# AGENDA OAK BAY ADVISORY DESIGN PANEL

- 1. Call to Order
- 2. Adoption of Minutes from February 5, 2019
- 3. Approval of Agenda and Late Items
- 4. Old Business
  - a) DVP00090 / ADP00105 2970 Rutland Road To permit an addition to a single family home.
- 5. New Business
- 6. Information Items
- 7. Next Meeting

The March 5, 2019 meeting of the Advisory Design Panel includes a review of proposed renovations to an existing single family dwelling at 2970 Rutland Road. The proposal includes a request to vary the provisions of the District of Oak Bay Zoning Bylaw No. 3531 by permitting an increase to the maximum Roof Height, Building Height, and Occupiable Height. The proposal would also relax the required interior side lot line setback.

- LARGE SITE PLAN -

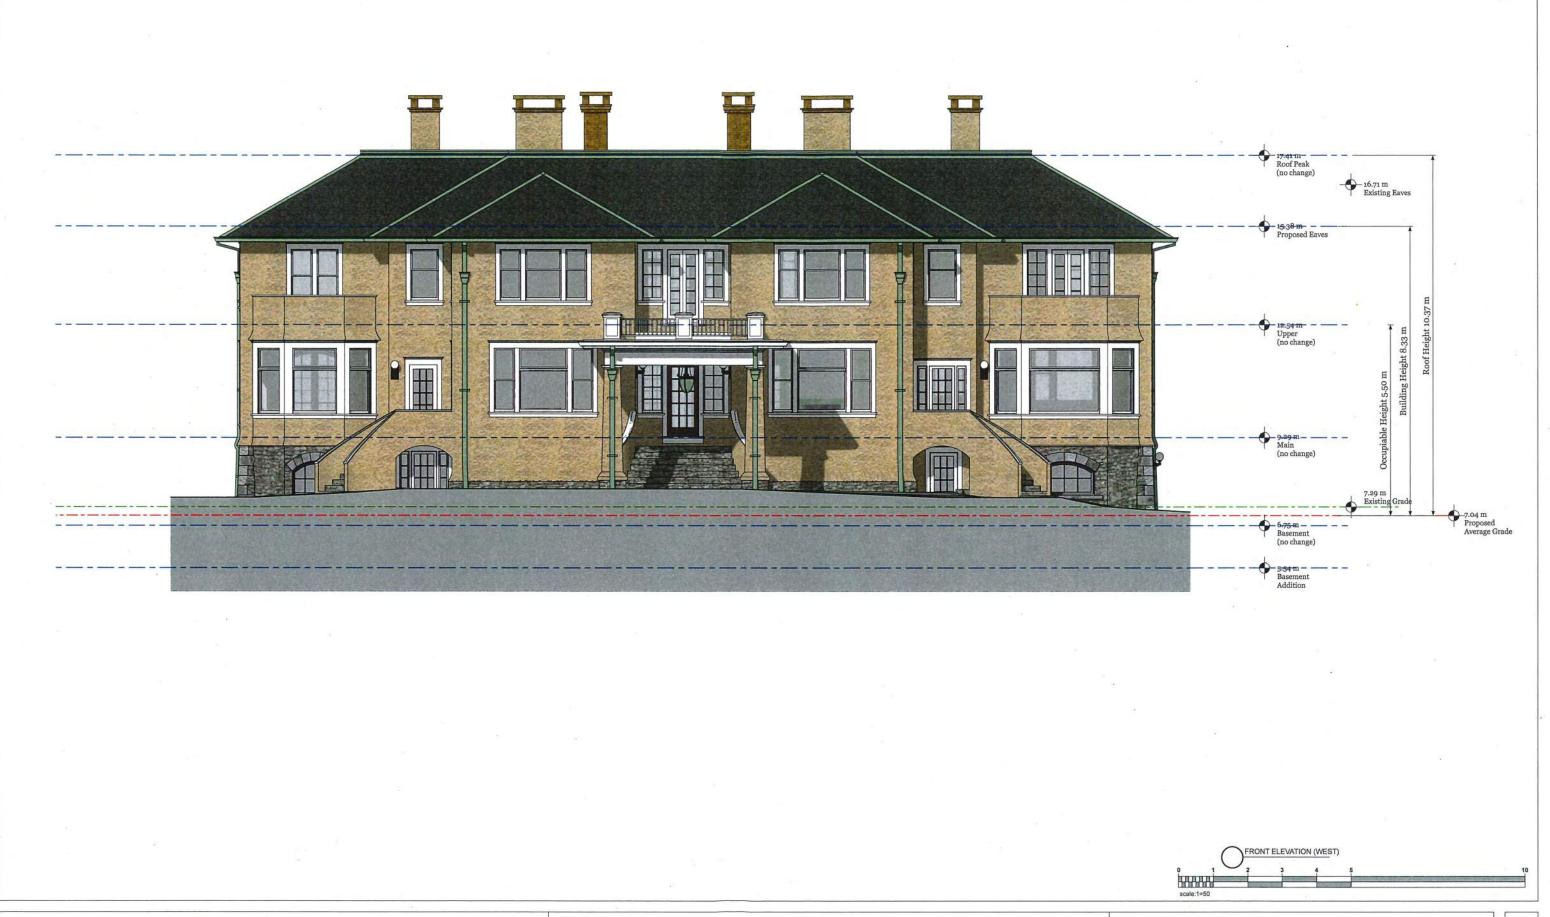
- Setbacks. The proposal would reduce the interior side lot line setback further than the existing conditions. The reduced setback brings the building footprint closer to the north lot line and does not reinforce the residential park atmosphere.

- Relationship to adjacent buildings. The front façade of the existing 1913 home is maintained however the proposed addition will further crowd the north property line.

David & Jess Gustavson Canopy Cover 2970 Rutland Road and 3140 Beach Drive PLAN

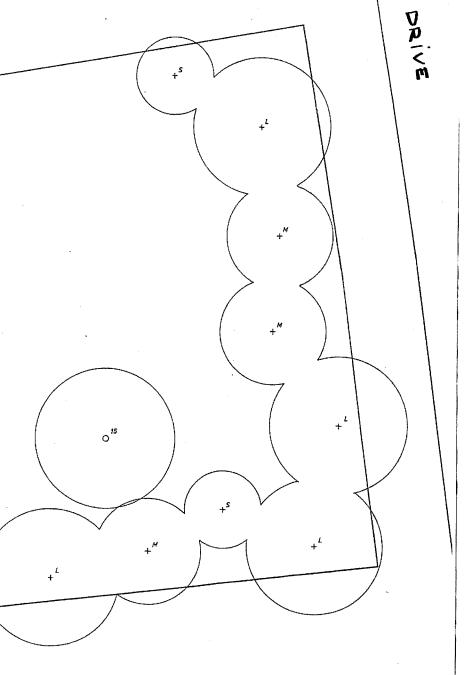
There is one bylaw protected tree that will have to be removed for the construction of the proposed house. This is tree # 442, an English walnut and by the current plans it appears to be located inside the proposed footprint so will not require replacement under the bylaw. Other bylaw protected trees and boulevard trees are to be retained and are shown as protected in the plan.

Canopy cover for the combined new lot is currently heavily weighted to the lot on Rutland. The old lot off of Beach drive has only approximately 200 square meters of canopy cover from the three oaks still on the property. There is a planting plan for the lot off of Beach Drive with a number of trees listed. The calculated canopy cover using the UFS appendix brings the proposed canopy cover up to the required canopy cover. The plan leaves a large amount of open space through the center of the lot.
